MAS003505 RU 23-04

Rapid Update 608 MC20 – Rear Under Tank Frame Washers

DATE: APRIL 4 2023

Figure 1

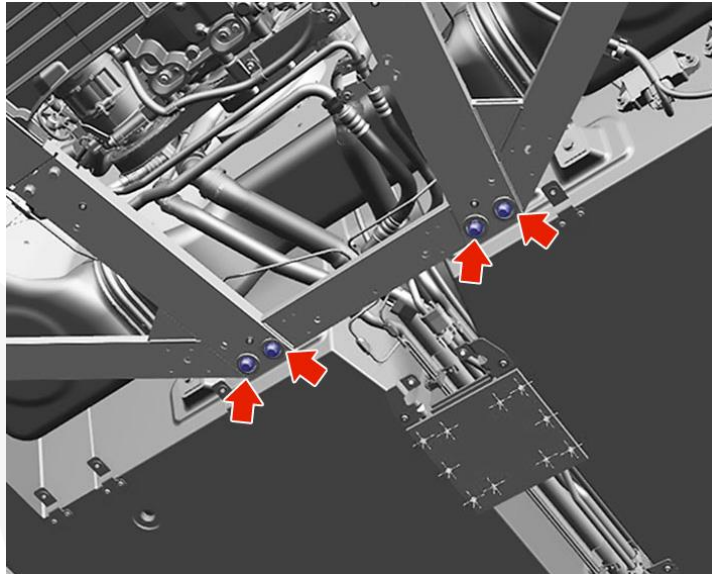
To improve the acoustic comfort of the vehicle, washers were added to the "Under Tank Frame" screws during assembly. The introduction of this component brings considerable benefits in the reduction of vibrations and noise coming from the sub-frame. The rework procedure will require restoring 4 missing washers.

1. Always check ModisCS+ to see if the vehicle is involved in this action and if it has not been previously performed.
2. Safely lift the vehicle on a lift and remove the "REAR AERODYNAMIC CENTRAL COVER".
Refer to workshop procedure: **09.14.090 00 REAR AERODYNAMIC CENTRAL COVER**
3. Identify the 4 (four) screws indicated in **Figure 1**.

5. Repeat the same procedure for the 3 remaining screws indicated in **Figure 1**.
6. Restore any removed components by following the reverse procedure.
7. procedure complete.

Figure 2

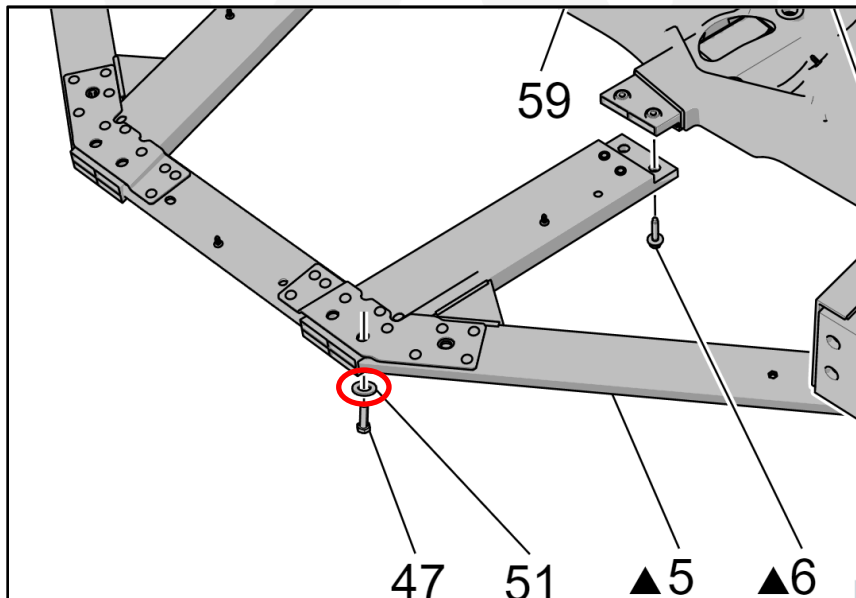
4. Remove one screw at a time from the frame and insert one washer for each screw (one washer per screw) (**Figure 2**). Reinstall the screw and torque it to **50Nm** (36.9 ft-lb).
